ADDENDUM NO. 2

Date of Addendum: July 29, 2016

PROJECT NAME: Sims North Wastewater Treatment Plant (WWTP) Waste and Debris
Offloading and Disposal Station

PROJECT NO: WBS No. R-000265-0081-4

C TYP. 1 LIGHT POLE BASE DETAIL
N T S

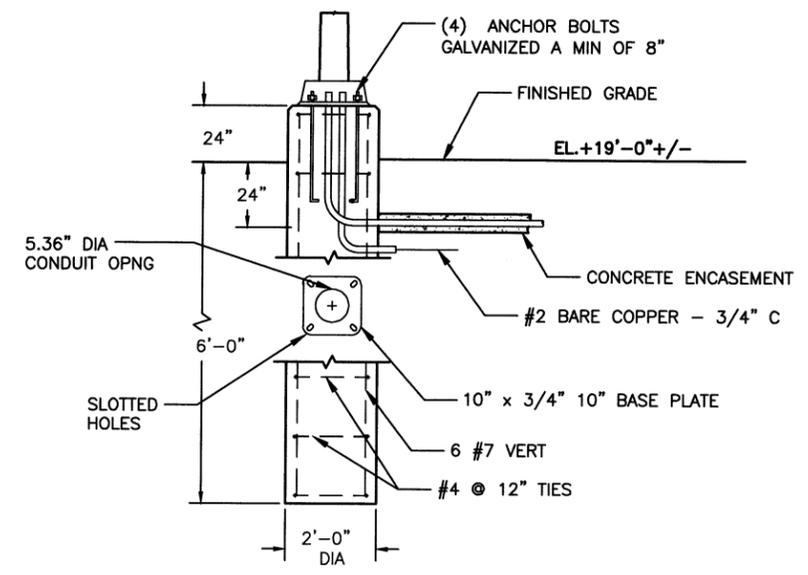
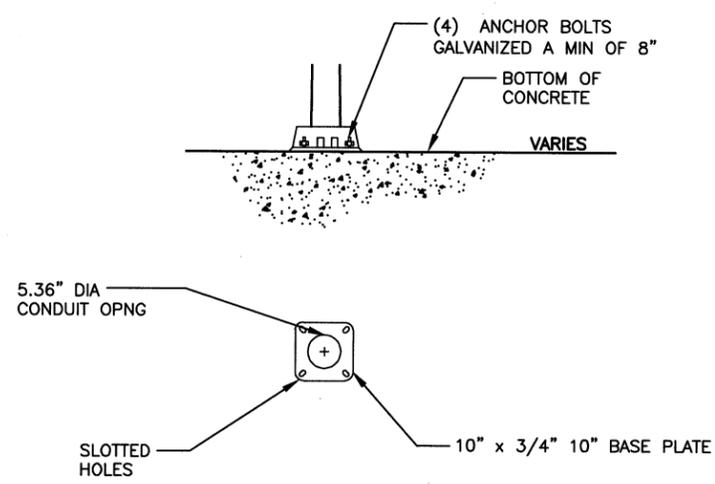
17. Drawing S-1 (sht 20), General Note 9 states "Anchor bolts, nuts and washers shall conform to ASTM A-316 stainless steel." Drawing S-10 (sht 29) Light Pole Base Details indicate galvanized anchor bolts. Are these anchor bolts to be stainless steel or galvanized?

Response: Anchor bolts called out on S-10 are specific to the light pole base only.
